Project	<b>IEEE 802.16 Broadband Wireless Access Working Group</b> < <a href="http://ieee802.org/16">http://ieee802.org/16</a> >	
Title	<b>Comments on MS initial ranging in non-transparent RS systems</b>	
Date Submitted	<b>2007-09-09</b>	
Source(s)	Kanchei (Ken) Loa, Yi-Hsueh Tsai, Yung-Ting Lee, Hua-Chiang Yin, Shiann-Tsong Sheu, Youn-Tai Lee,  Institute for Information Industry 8F, No. 218, Sec. 2, Dunhua S. Rd., Taipei City 106, Taiwan  [add other co-authors here]	Voice: +886-2-27399616 Fax: +886-2-23782328 <a href="mailto:loa@iii.org.tw">loa@iii.org.tw</a>
Re:	IEEE 802.16j-07/043: "IEEE 802.16 Working Group Working Group Letter Ballot #28"	
Abstract	This contribution proposes to use "MR-Code-REP header" instead of "RNG-REQ message with MS ranging indicator equal to 1" to request CDMA-Allocation_IE for MS.	
Purpose	Text proposal for 802.16j Draft Document.	
Notice	<i>This document does not represent the agreed views of the IEEE 802.16 Working Group or any of its subgroups. It represents only the views of the participants listed in the "Source(s)" field above. It is offered as a basis for discussion. It is not binding on the contributor(s), who reserve(s) the right to add, amend

Figure 95e—Handling CDMA initial ranging code at a non-transparent RS

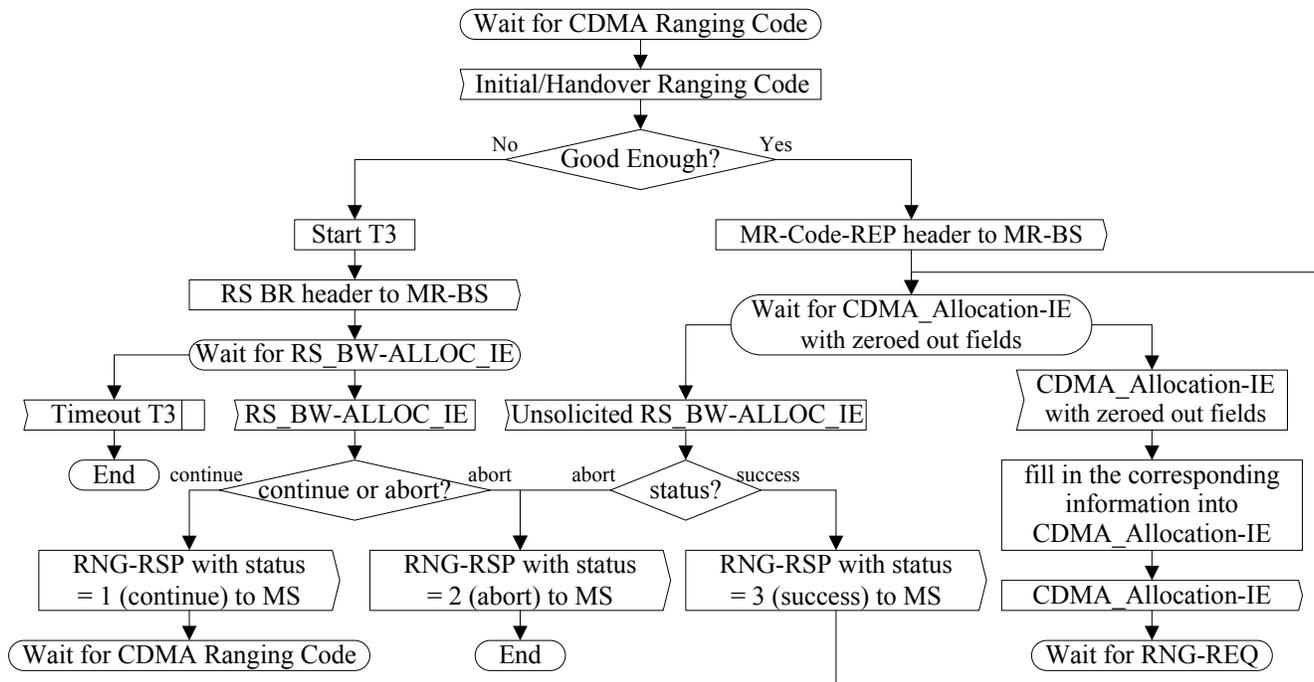
[Merge figure 95e and figure 95f as following indicated:]

Figure 95g Handling **RNG-REQ MR Code-REP** in non-transparent mode at MR-BS **(Part 1)**

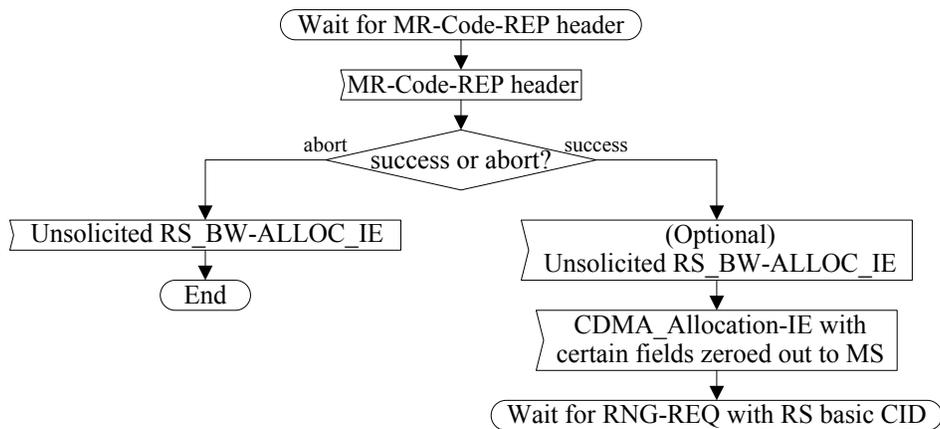
[Replace figure 95g as following indicated:]
